**Specialist Professional and Technical Services
Framework
Task Ref: 1-286**

**Task Title: Road Safety Audit - Maintain & Develop
Road Safety Audit Database**

**QUARTERLY REPORT
April 2019 to June 2019**

Figure 2-4 Sign mounted lower than indicated on drawing

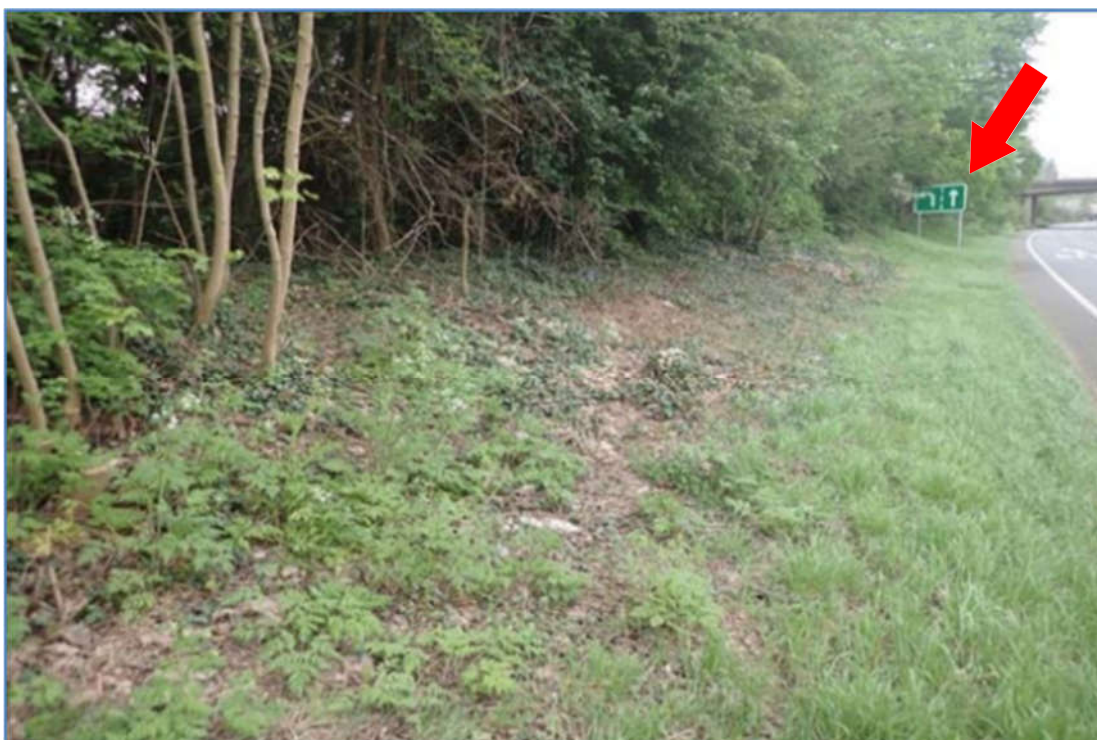
A problem in one of the reports reviewed this quarter relates to a sign (on a sloping embankment) having post-heights lower than indicated on the drawing and cites a risk of increased severity of injury if struck. It states:

“The mounting height of the left-hand post is only at 1.37m. The drawing for this sign indicates the mounting height to be 2.11m and 1.8m respectively. The lower edge of the traffic sign could increase the severity of injury to vehicle occupants if an errant vehicle collided into this sign.”

It is possible that the RSA team noticed the discrepancy between the mounting height described on the drawing and the height of the constructed sign and felt that, in itself, this was noteworthy. However, RSA is not intended to be a technical check of compliance with design requirements.

Whilst concern about the risk of increased severity might, in fact, be justified in this case, RSA teams should consider the reasoning behind construction decisions before making their recommendations and they are required to request such additional information where appropriate. In this case, the mounting height provided might have been intended to optimise forward visibility (if the approach is on an uphill gradient for example). If so, raising the mounting height would only exacerbate the problem. No mention is made about the nearby vegetation and how that might obscure the sign if it were raised.

“It is recommended that the sign is mounted at the correct height and as shown on the design drawing.”

The outcome of such deliberations should be summarised within the problem text to give it context and to illustrate that the recommendation is based on complete reasoning.
